Accessibility Compliance Report For DA Application

Project Address: 22-24 Raglan St, Manly NSW
Prepared For: Anderson Ave Pty Ltd

Issue No: B
Issue Date: 21/12/2022
Report No: DA-22284

Att. 01 CARLISLE ARCHITECTS Floor Plans Issue. A Dated 20/12/2022

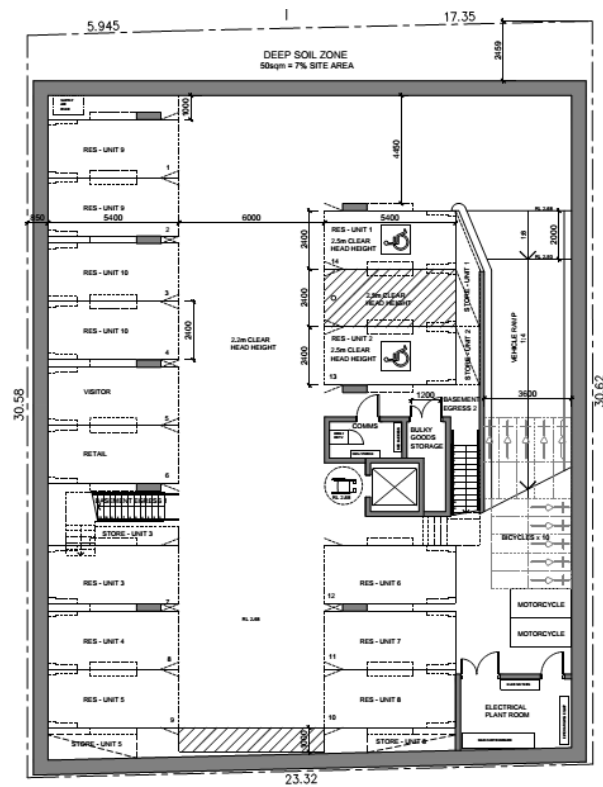
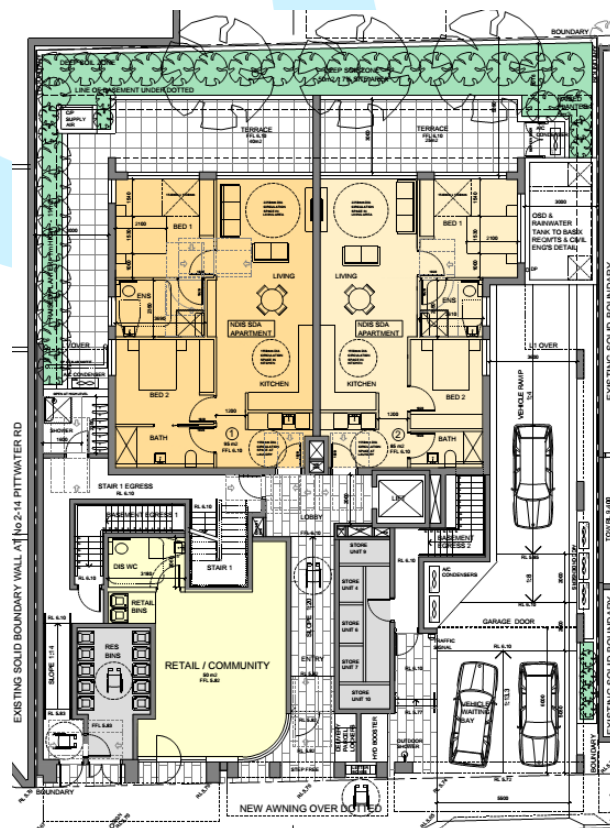
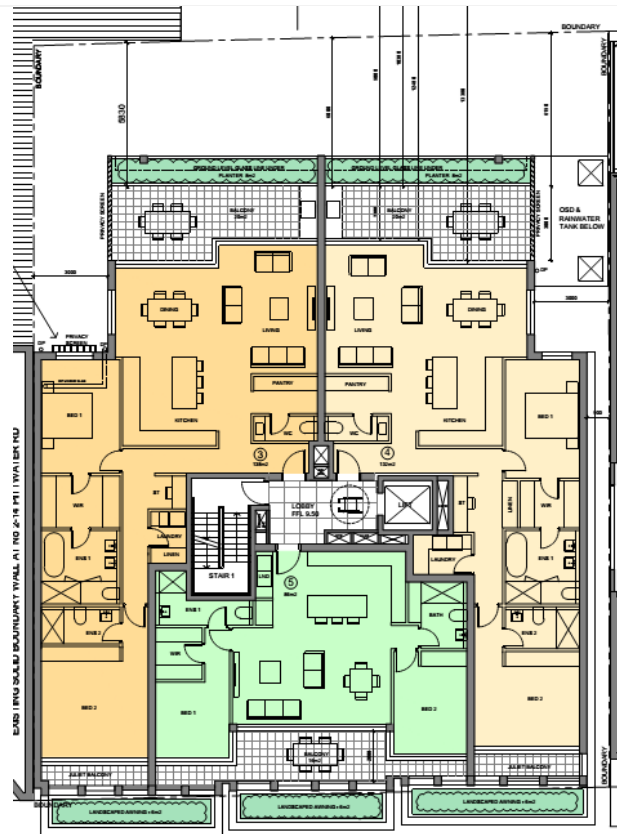
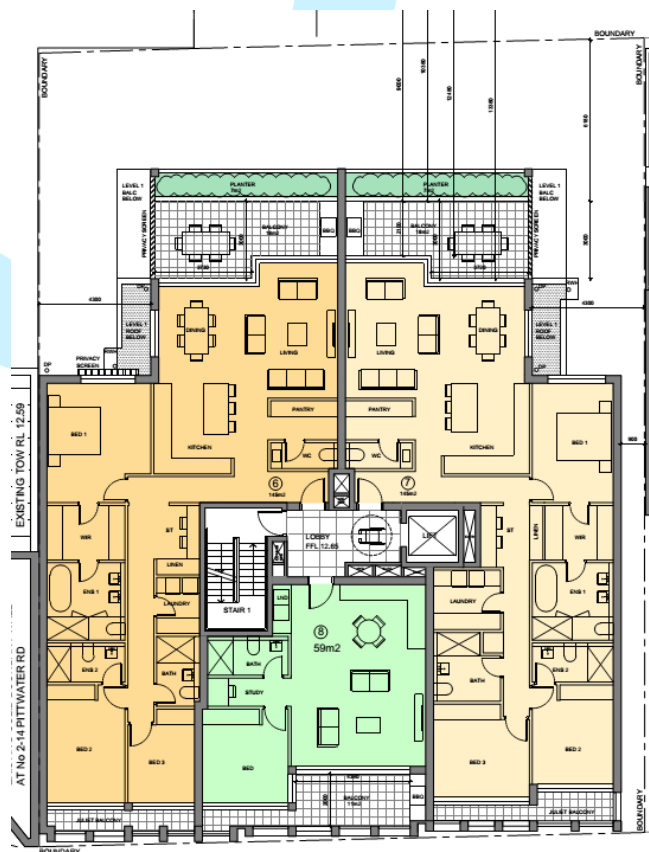
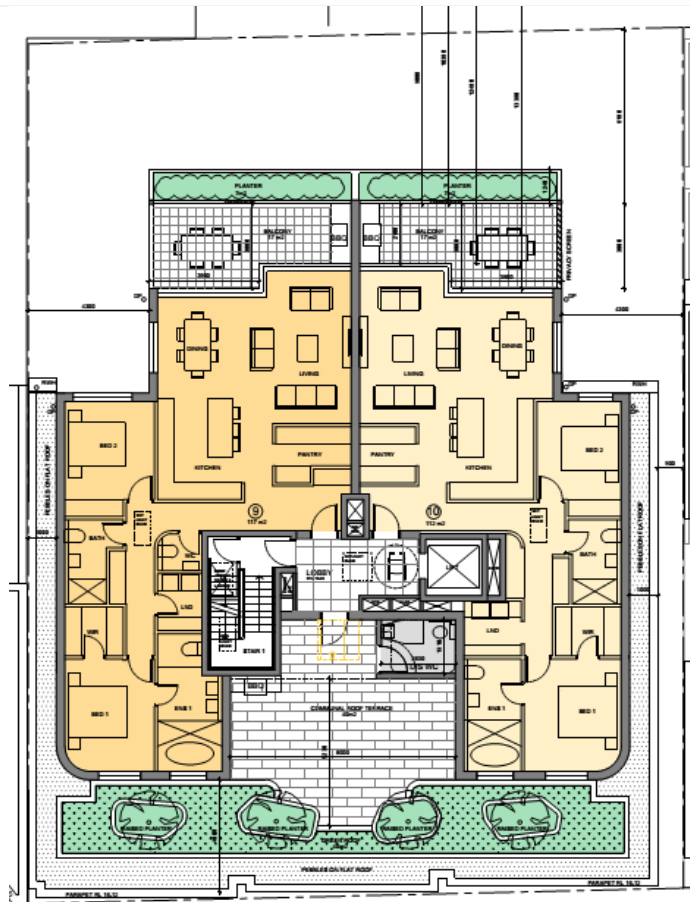
Notes: see Att.01 – Capable of compliance at CC stage

Notes: see Att.01 – Capable of compliance at CC stage

Notes: see Att.01 – Capable of compliance at CC stage

Notes: see Att.01 – Capable of compliance at CC stage

Notes: see Att.01 – Capable of compliance at CC stage

Att. 01 CARLISLE ARCHITECTS Floor Plans Issue. A Dated 20/12/2022

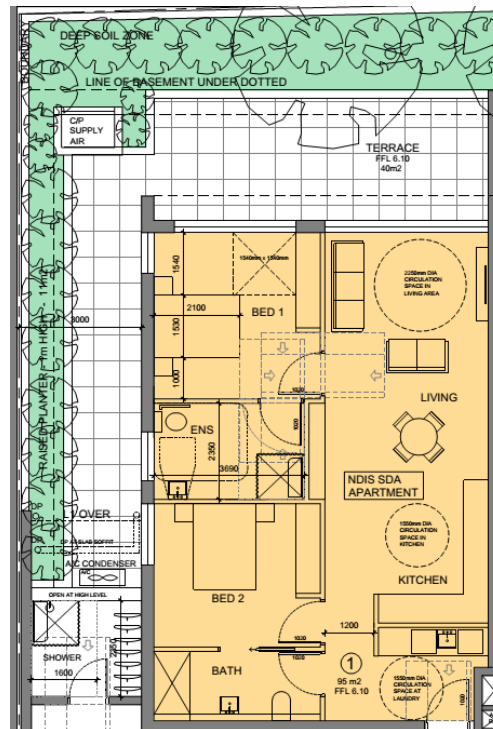
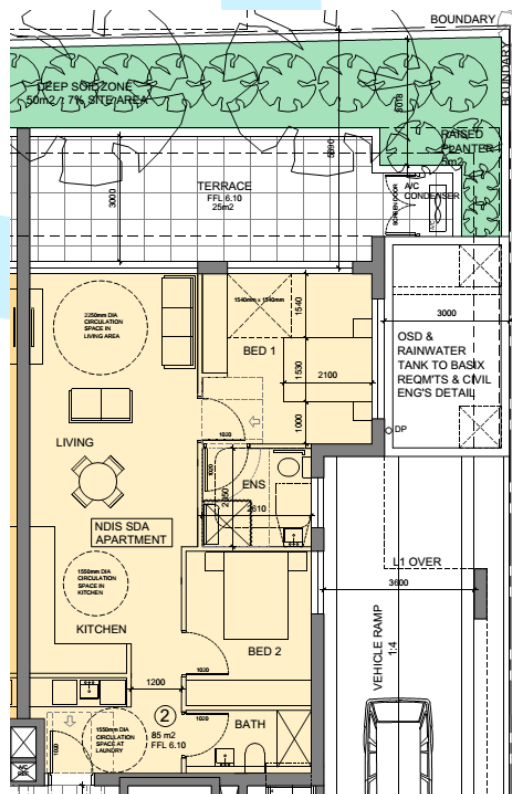
This schedule is a list of essential features to be incorporated into a housing unit for it to be termed an 'Adaptable House'. **2 NDIS SDA units have been provided at Ground Level exceeding the requirements set in the table below and above AS4299 standards as they will be constructed to "High Physical Support – HPS" Design standards.**

However, a total of 3 "Three" Adaptable units are required as per Manly DCP (25% of the total amount).

Units **1 and 2** have been chosen as "NDIS SDA units"
